SERVICE BULLETIN

M-1240 January 20, 2009

AUSTRALIAN NOISE LABEL NON-COMPLIANCE REGULATORY RECALL 0604

Figure 1. Noise Label Location: FXDSE²

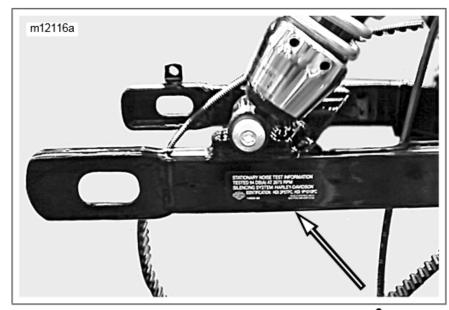
See Figure 1 for FXDSE² noise label location.

We have enclosed the correct label part number to be applied to your motorcycle. The Australia noise label is located on the right side of the swingarm on your motorcycle, forward of the axle. You may apply the label directly over the incorrect label by the following instructions: clean and dry the original label, remove the backing from the enclosed new label, and apply the new label by starting at one edge and slowly press across the label.

When the motorcycle is in for service, inspect the label and confirm that the the recall is still open. If the old label is visible, install a **new** label over the old. Additional labels are available through Harley-Davidson Australia to Australian dealers.

Figure 2. Correct FXDSE² Noise Label for Australia

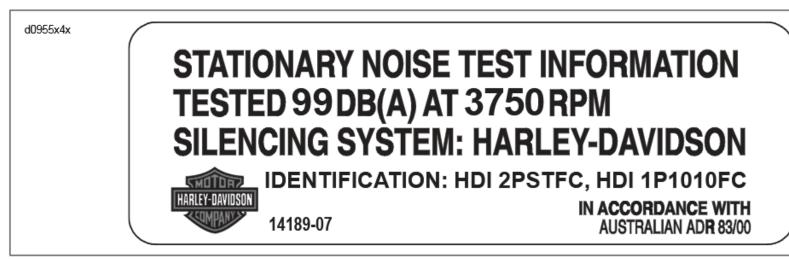
Some of these model motorcycles may have been shipped with an incorrect Australia Noise label part number 14000-07. The label inaccurately lists 93dbA @ 2675 RPM. The proper Australia Noise label for these motorcycles is part number 14189-07 and correctly lists 99dbA @ 3750 RPM.

See Figure 2. The Correct part number is 14189-07

- Clean surface of old label with hot, soapy water. Thorough cleaning is necessary for new label to adhere to old label.
- Dry surface completely before installing new label.
- 3. Install new label over old label.
